Access Compliance Report

Public Rights-of-Way

(Pedestrian Signals)

Intersection ID: N/A	Main Street:	Cross Street: N/A	Location: N/A
ADA ID: 21BE3311BD40	Signal Type: One Push Button-APS	Overall Compliance: No	Severity Score: BTN 1: N/A BTN 2: N/A No BTN: N/A
Codes/Mitigation Info/Possible Solution		Field Measurements/Component Compliance

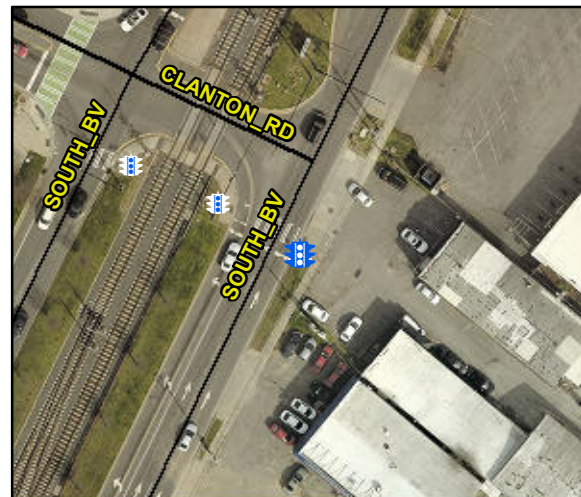
Surveyor Notes: N/A

PROW/ADA: TMUTCD 4e.08, R406.2, R404.7.3, R209.1, MUTCD 4e.10

Compliance	Description	Data	Compliance	Description	Data
	Button Count	Button1	N/A	Distant to Additional Button (in)	N/A
	Additional Button Present?	No		Additional Button ID	N/A
N/A	Signal Buttons Required?	N/A	N/A	Additional Ped Posts Required	N/A
	How Many Ped Street Xings?	1		Located In An Island/Median?	No
N/A	B 1 Sign Present?	Yes	N/A	B 2 Sign Present?	N/A
Yes	B 1 Sign Purpose?	Yes	N/A	B 2 Sign Purpose?	N/A
Yes	B 1 Sign Lettering & Contrast?	Yes	N/A	B 2 Sign Lettering & Contrast?	N/A
Yes	B 1 Parallel To XWalk?	Yes	N/A	B 2 Parallel To XWalk?	N/A
Yes	B 1 PAR to Button?	Yes	N/A	B 2 PAR to Button?	N/A
Yes	B 1 PAR to XWalk?	Yes	N/A	B 2 PAR to XWalk?	N/A
Yes	B 1 Clear Floor Space?	Yes	N/A	B 2 Clear Floor Space?	N/A
N/A	B 1 FWD Approach?	Yes	N/A	B 2 FWD Approach?	N/A
N/A	B 1 FWD Approach Constrained?	No	N/A	B 2 FWD Approach Constrained?	N/A
No	B 1 FWD Approach Reach (in)	16.0	N/A	B 2 FWD Approach Reach (in)	N/A

N/A	B 1 FWD Approach Width (in)	N/A	N/A	B 2 FWD Approach Width (in)	N/A
N/A	B 1 FWD Approach Obstruction?	Yes	N/A	B 2 FWD Approach Obstruction?	N/A
N/A	B 1 FWD Approach Obstruction Dist (in)	15.0	N/A	B 2 FWD Approach ObstructionDist (in)	N/A
N/A	B 1 PARA Approach?	Yes	N/A	B 2 PARA Approach?	N/A
N/A	B 1 PARA Approach Constrained?	No	N/A	B 2 PARA Approach Constrained?	N/A
No	B 1 PARA Approach Reach (in)	16.0	N/A	B 2 PARA Approach Reach (in)	N/A
N/A	B 1 PARA Approach Width (in)	N/A	N/A	B 2 PARA Approach Width (in)	N/A
N/A	B 1 PARA Approach Obstruction?	Yes	N/A	B 2 PARA Approach Obstruction?	N/A
N/A	B 1 PARA Approach Obstruction Dist (in)	15.0	N/A	B 2 PARA Approach ObstructionDist (in)	N/A
Yes	B 1 Clear Floor Space Slope (%)	2.6	N/A	B 2 Clear Floor Space Slope (%)	N/A
Yes	B 1 Clear Floor Space XSlope (%)	1.8	N/A	B 2 Clear Floor Space XSlope (%)	N/A
N/A	B 1 PAR Slope (%)	3.4	N/A	B 2 PAR Slope (%)	N/A
Yes	B 1 Height (in)	37.0	N/A	B 2 Height (in)	N/A

Yes	B 1 Clear Xing Direction?	ClearlyMarked	N/A	B 2 Clear Xing Direction?	N/A
	B 1 Crossing Direction	To NW		B 2 Crossing Direction	N/A
No	B 1 DistanceTo XWalk (in)	61.0	N/A	B 2 DistanceTo XWalk (in)	N/A
No	B 1 DistanceTo Curb (in)	73.0	N/A	B 2 DistanceTo Curb (in)	N/A
Yes	B 1 Diameter (in)	2.0	N/A	B 2 Diameter (in)	N/A

Possible Solutions: Replace Signal Push Button With APS Button on New Post. Remove & Relocate Sign.
